Important Notices

TOSHIBA Microcontrollers TLCS-870 Family TLCS-870/C1 Series

Restrictions on the Voltage Detection Circuit

Datasheet Corrections: Electrical Characteristics of the Power-On Reset Circuit

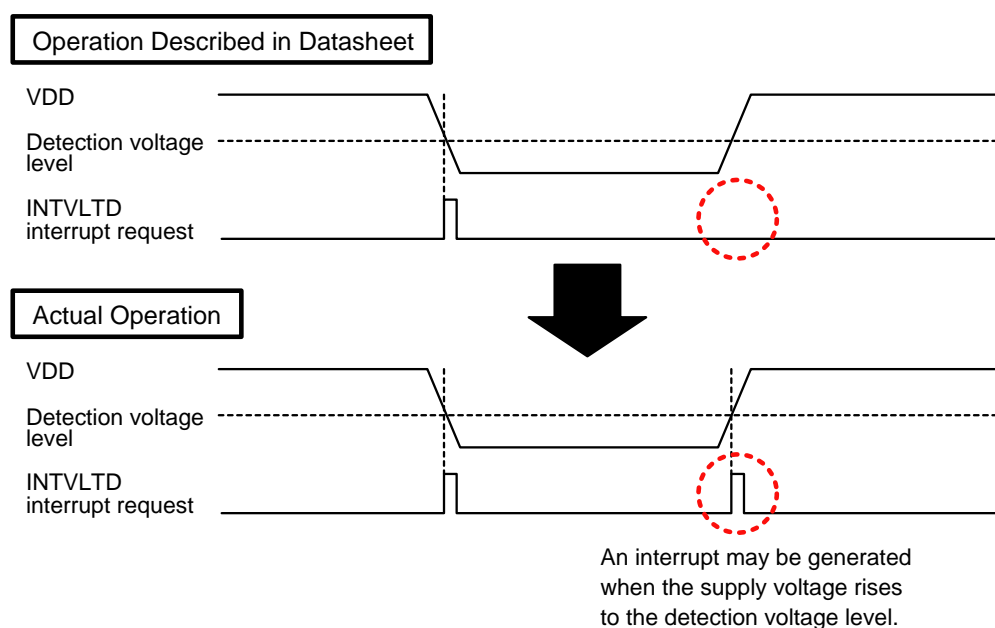
1. INTVLTD Interrupt Request

When interrupt generation is enabled in the voltage detection circuit, an INTVLTD interrupt request may be generated not only when the supply voltage falls to the detection voltage level, but also when it rises to the detection voltage level.

In ICE mode of the In-Circuit Emulator (TMP89C900), no interrupt request is generated when the supply voltage rises to the detection voltage level. Therefore, with products supporting the In-Circuit Emulator (TMP89C900), the interrupt generation operation may differ between the development tool and the actual product.

2. Releasing STOP Mode by Voltage Detection

The SRSS bit in the voltage detection control register 2 (VDCR2) provided for releasing STOP mode by voltage detection cannot be used because it does not function as expected.

Do not use the INTVLTD interrupt for voltage detection. The voltage level should be regularly checked using other timing such as the execution cycle of the main program. VDCR1<VDxSF> (x=1, 2) can be used to check the voltage level. However, if the operating voltage is near the detection voltage, the VDCR1<VDxSF> value may become unstable. It is recommended that VDCR1<VDxSF> be tested multiple times to determine the voltage level.

Always set VDCR2<SRSS> to "00". Use the STOP pin to release STOP mode.
